Use of Surrogate Data at GSI Response to SC&A Review Dated July 16, 2012 Prepared by Dave Allen, DCAS August 2012

On July 16, 2012, SC&A released a review of the use of surrogate data at GSI which evaluated the use of surrogate data at GSI against the Advisory Board's Surrogate Data Criteria. This paper provides NIOSH's response to that review.

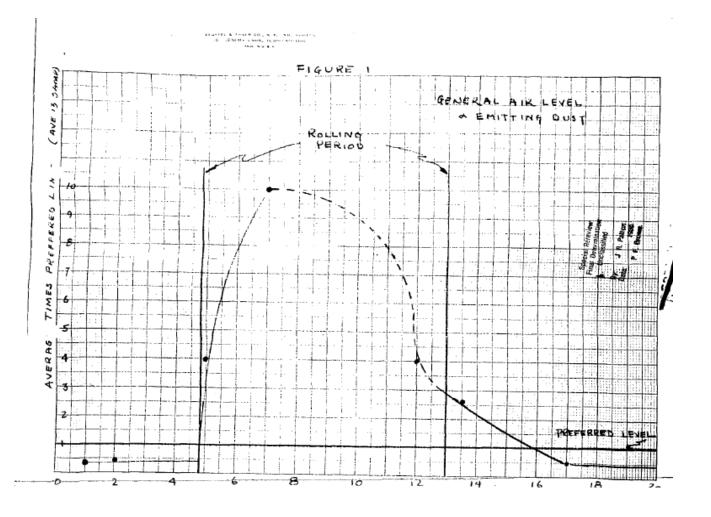
SC&A appears to be indicating the airborne contamination calculation in Appendix BB is not plausible because uranium work at GSI was intermittent and thus "large flakes" of uranium oxides would not be quickly ground into dust under foot or forklift traffic. This results in the equilibrium value in Harris and Kingsley for a continuous operation being higher than that expected at GSI.

NIOSH agrees that work with uranium at GSI was intermittent and thus it is less likely that an equilibrium concentration would be reached. This implies the value in Appendix BB is too high. However, the argument used by SC&A appears to be based on the idea that the resuspension of surface contamination is the major source of airborne contamination during operational periods.

In reality, airborne contamination while working with uranium metal would initially be caused entirely by disturbing uranium oxides on the surface of the uranium metal. This contamination would be relatively consistent from one piece of uranium to the next. As additional pieces of uranium metal are brought in, a fresh source of contamination is available. Since this source of airborne does not depend on the slow buildup of contamination, it occurs immediately and builds up quickly to a maximum.

The other source of airborne, resuspension from surface contamination, will build up to a maximum more slowly as the surface contamination builds up from continued operations. This source of airborne is much lower than the operational source. This effect can be seen in Figure 1 which depicts the relative levels of airborne contamination during operational and post-operational period at Simonds Saw and Steel. The time scale in this figure is days. Once the rolling operations end, the airborne contamination decreases quickly to a steady level caused by resuspension. It should be noted that, at Simonds Saw and Steel, the uranium metal was heated and rolled resulting in a much larger fraction of the metal being oxidized. This would result in higher levels of airborne and surface contamination than would be seen with the movement of cold uranium.
